M5275 Evaluation Board Errata

This document identifies implementation differences between the M5275EVB and M5275EVBE and the description contained in the M5275EVB User's Manual. Check <http://www.freescale.com> for the latest updates.

Document Number: EB676
Rev. 0
02/2007

Figure 1. Example of Incorrect ASRAM Interface Found on EVBs

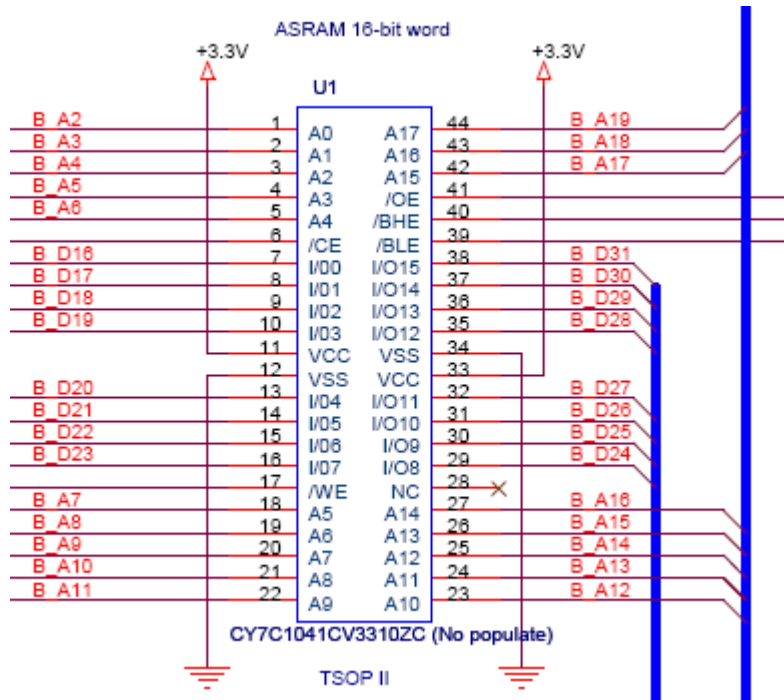
The EVB has a footprint for one 256 Kbytes × 16 asynchronous SRAM devices (Cypress Semiconductor – CY7C1041CV3310ZC). This memory device (U1) may be populated for benchmarking purposes. However, the EVBs have incorrectly interfaced to the ASRAM where addressing to (U1) is mapped [A0:A17] to the MCF5275's (U6) buffered address signals [B_A2:B_A19]. This is shown in Figure 1.

Figure 2. Example of Correct ASRAM Interface Found on EVBs.

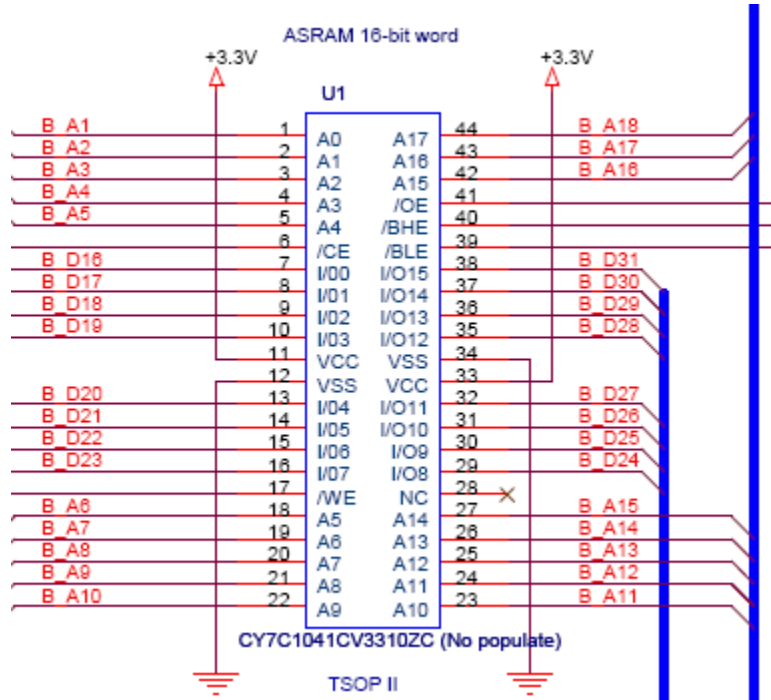
The EVBs should be interfaced to the ASRAM where addressing to (U1) is mapped [A0:A17] to the MCF5275's (U6) buffered address signals [B_A1:B_A18]. This is shown below in Figure 2.

The corrected addressing implementation is on the next revision of the evaluation board, M5275EVBE Rev. B.
